SAN FRANCISCO PLANNING DEPARTMENT

MEMO

TO: Architectural Review Committee (ARC) of the Historic Preservation Commission (HPC)

RE: **Review and Comment: 1170 Harrison Street**
Case No. 2015-016239ENV

OPTION C - PRESRVATION PROPOSED MASSING

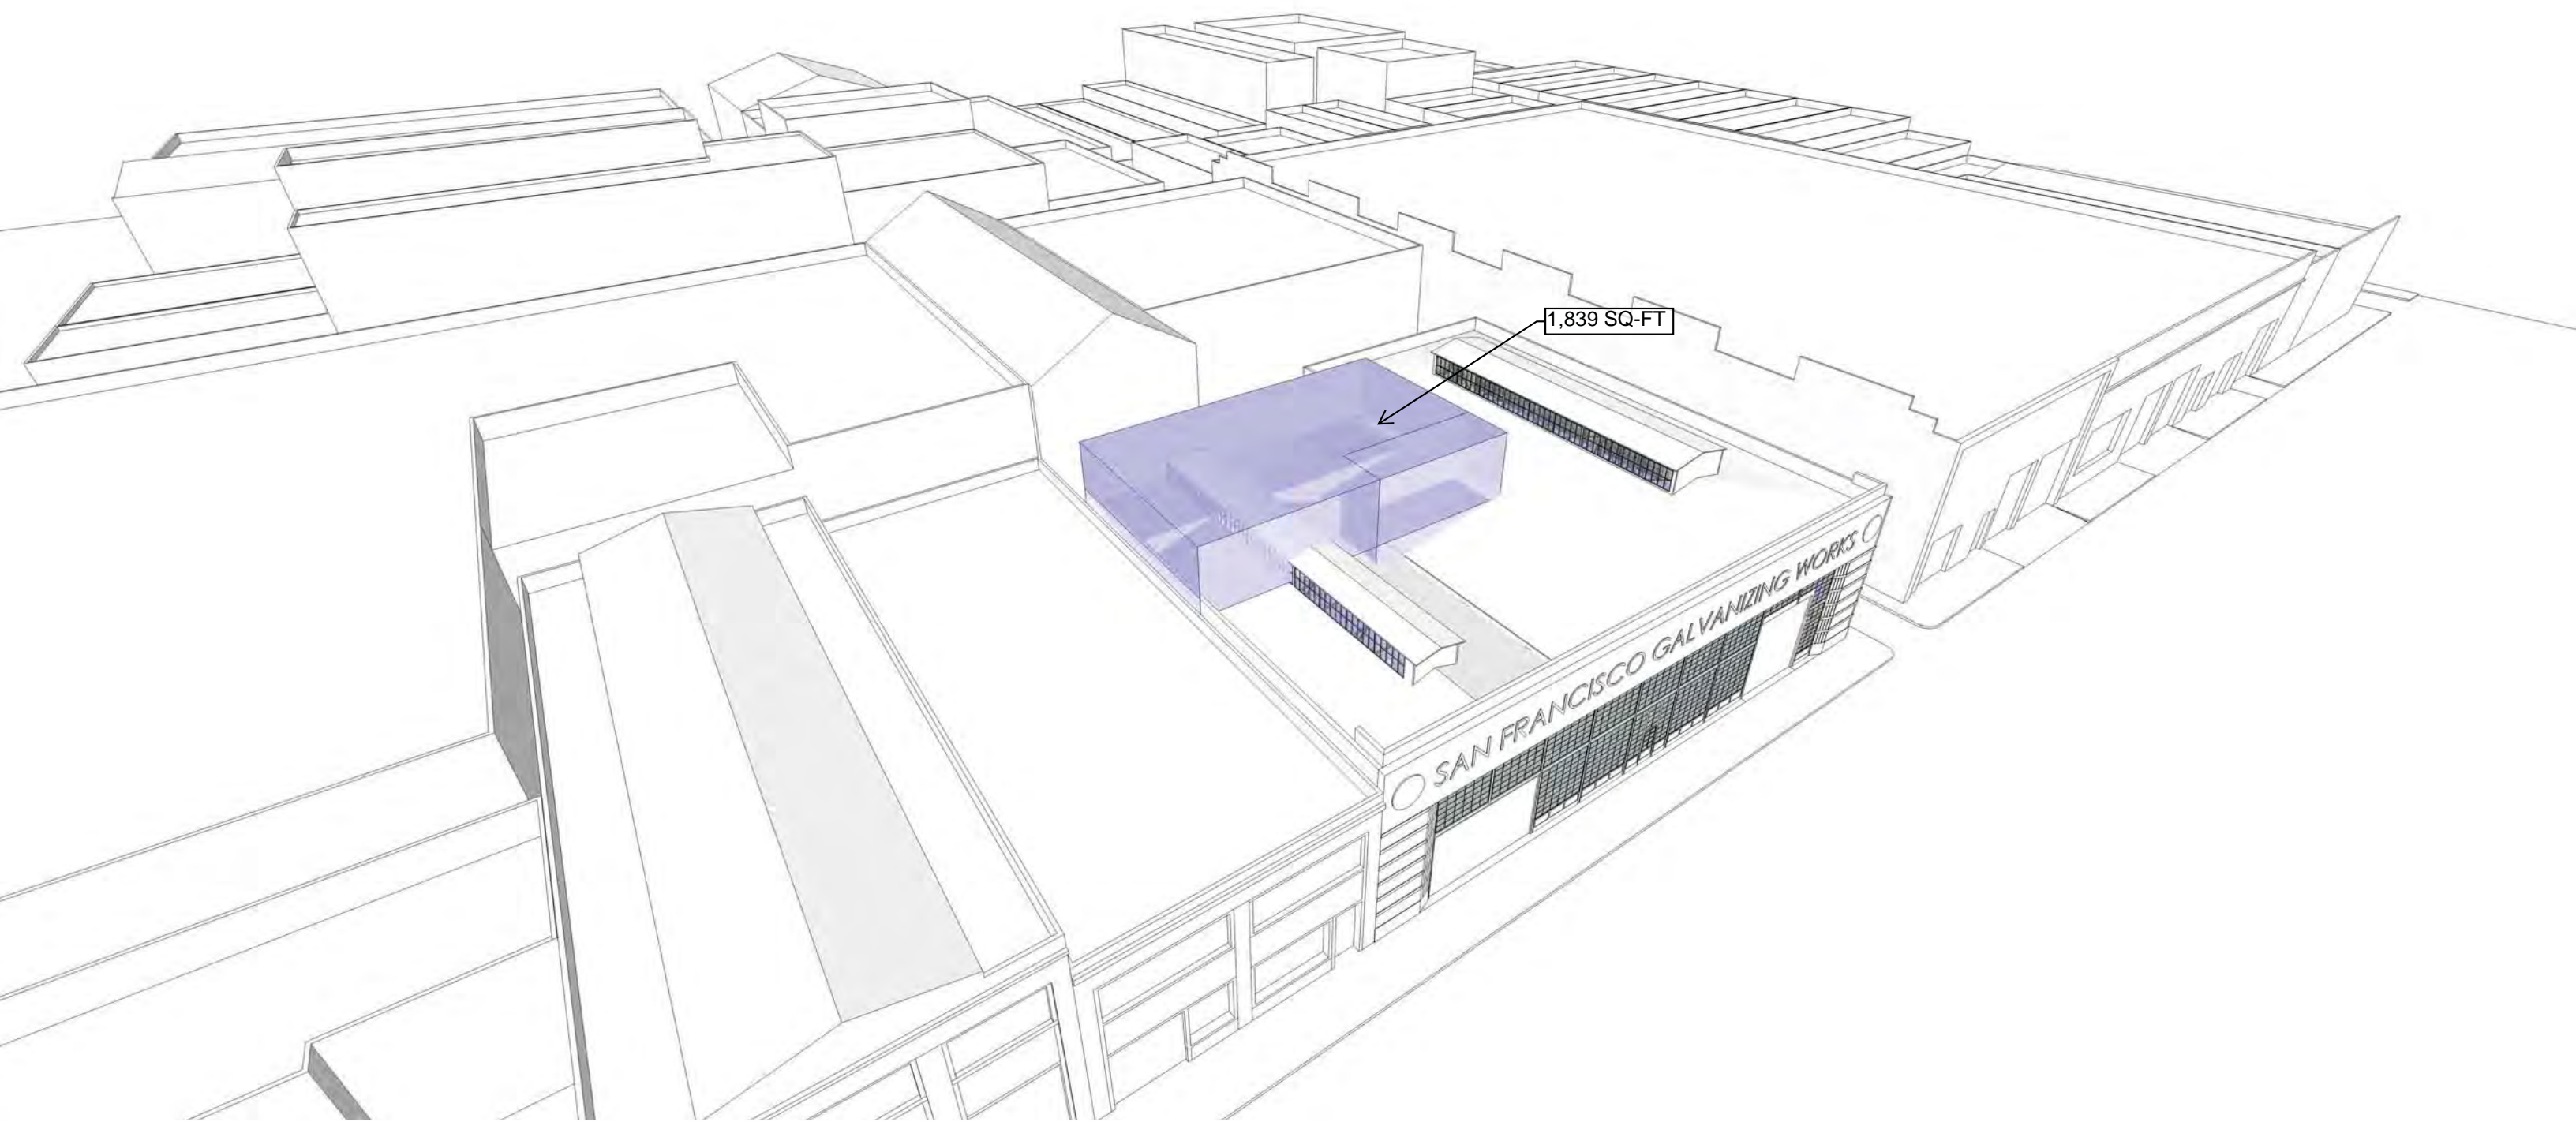
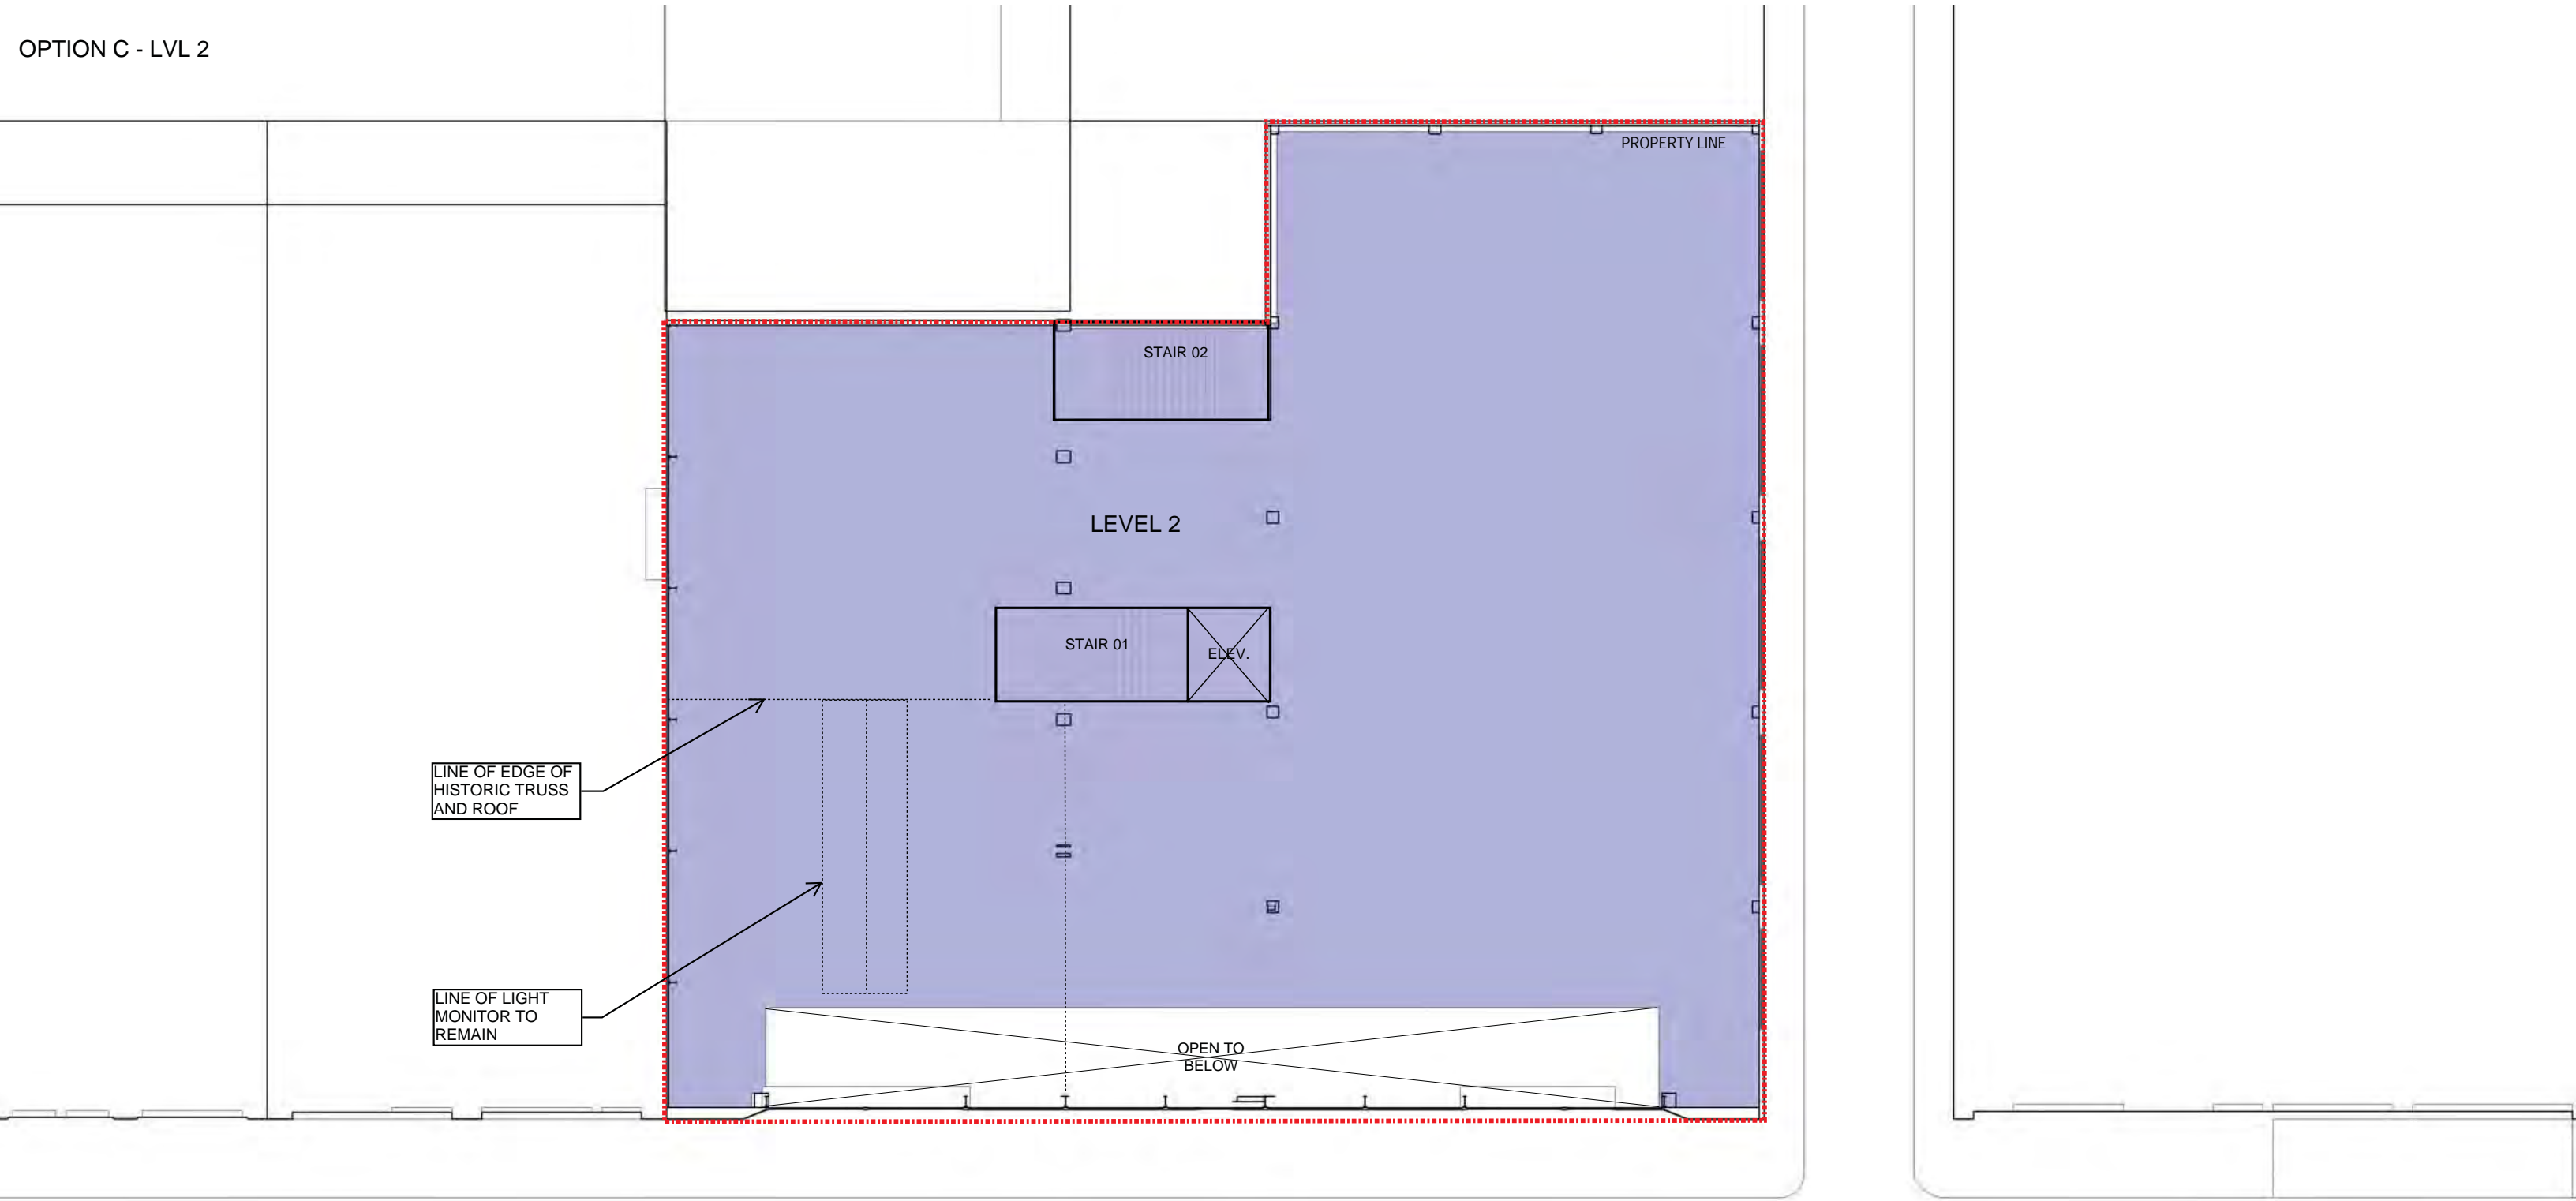
- a. In the first and preferred option, Staff recommends nesting the vertical addition in the middle of the roof to allow for the retention of both roof monitors in their entirety, as well as for the retention of a large percentage of the existing hip and gable roofs. Staff recommends a minimum 25 foot setback from the front façade to minimize visibility. This option has been rendered in the "Project Sponsor Submittal" and labeled as "Option B – Preservation Proposed Massing".
- b. In the second option, Staff recommends for the retention of 50 percent of the west monitor. With this option, staff recommends a minimum 40 foot setback from the front façade to retain the roof monitor and minimize visibility from the public

right-of-way. This option has been rendered in the “Project Sponsor Submittal” and labeled as “Option C – Preservation Proposed Massing”.

Exterior
Elevations -
Existing

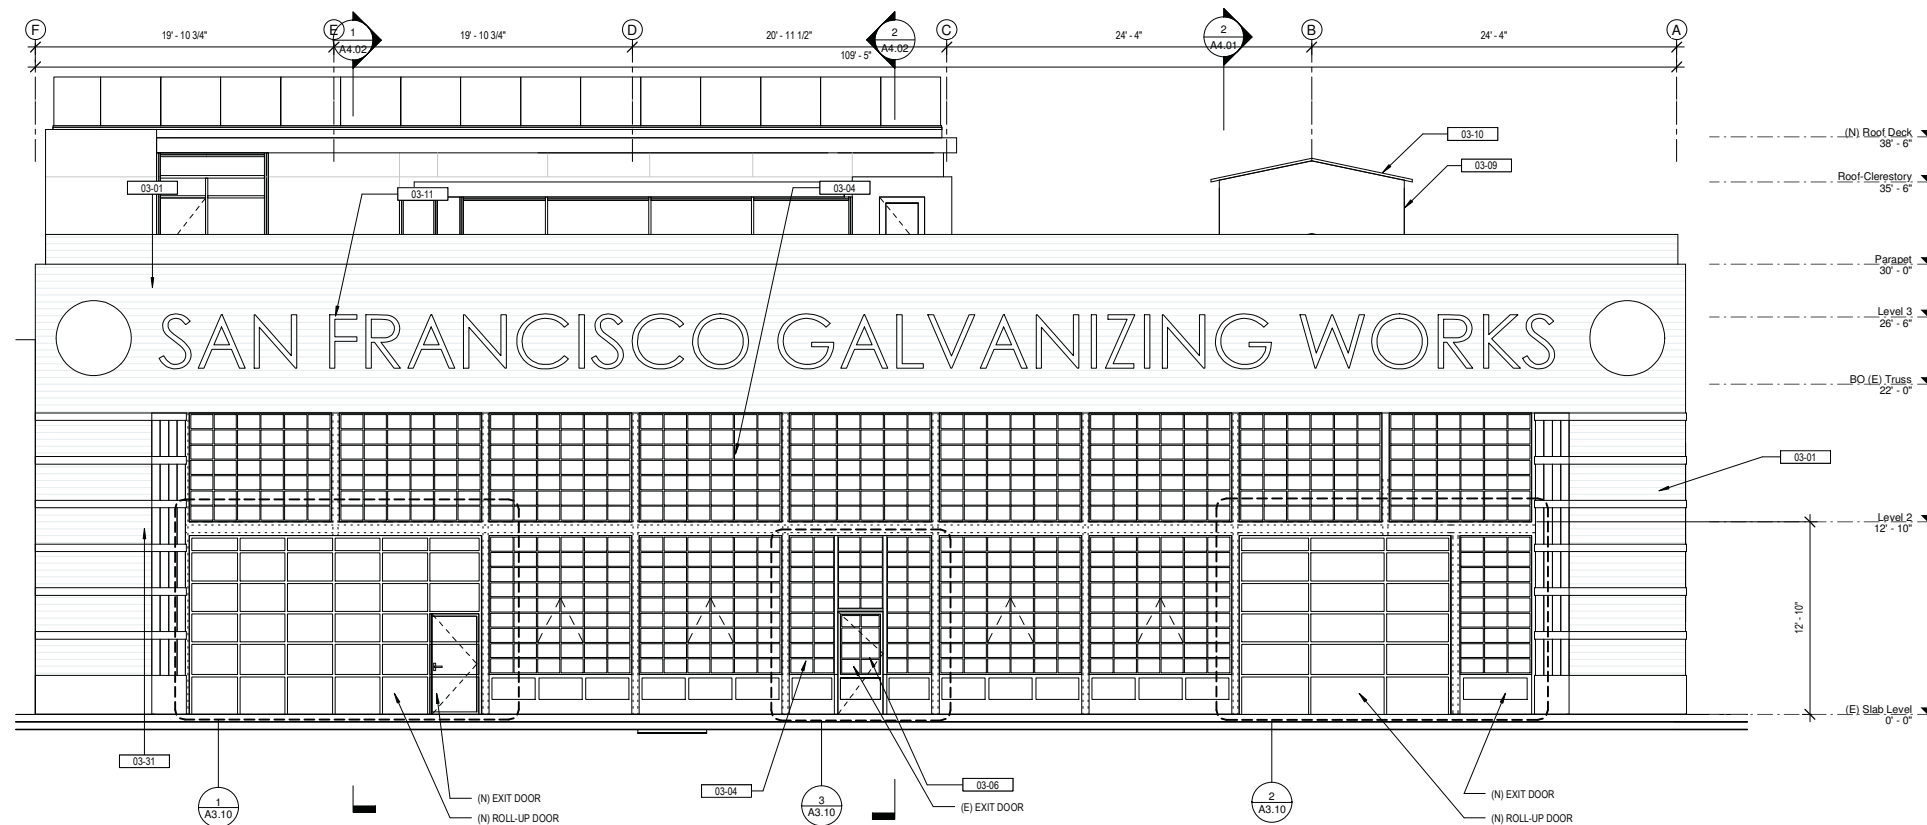
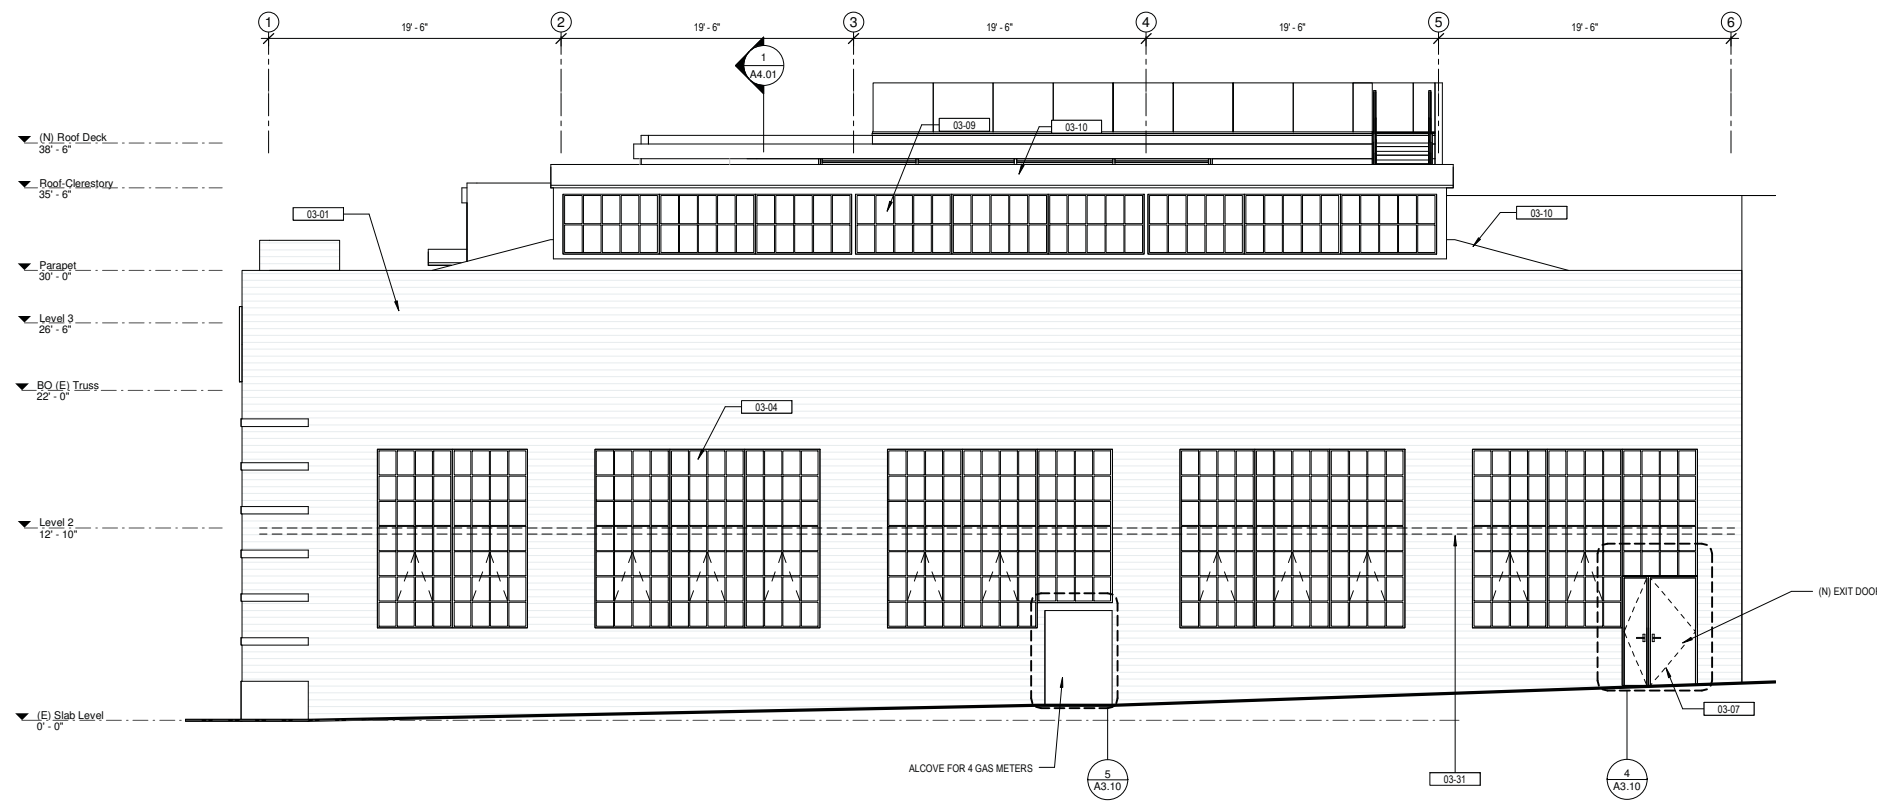
Harrison Street Elevation. The proposed project includes the restoration of features on the Harrison Street façade including: repair of the existing multi-lite industrial metal-sash window system, riveted steel mullions and pivot windows, and cast-in-place concrete Streamline Modern style façade. The project also includes alterations to the façade including: replacement of the existing roll-up garage doors with new multi-lite metal sectional overhead doors. The western opening will remain the same, while the eastern opening will be restored to its original size, matching the western opening.

Recommendation #3: Overall, the Department is supportive of the proposed restoration and alterations to the Harrison Street elevation and will undertake a complete analysis per the applicable Standards. Staff welcomes review and comment from the ARC in regards to the proposed project and recommendations on how to bring it further into conformance with the Standards and Article 10 of the Planning Code.

Berwick Place Elevation. The proposal includes the restoration of features on the Berwick Place façade and alterations including: repair of the existing multi-lite industrial metal-sash window system, removal of the existing exit door at center of façade and creation of alcove for gas meters, and the addition of a new exit door at rear of the façade that will remove a portion of the existing window.

Recommendation #3: Overall, the Department is supportive of the proposed restoration and alterations to the Berwick Place elevation and will undertake a complete analysis per the applicable Standards. Staff welcomes review and comment from the ARC in regards to the proposed project and recommendations on how to bring it further into conformance with the Standards and Article 10 of the Planning Code.
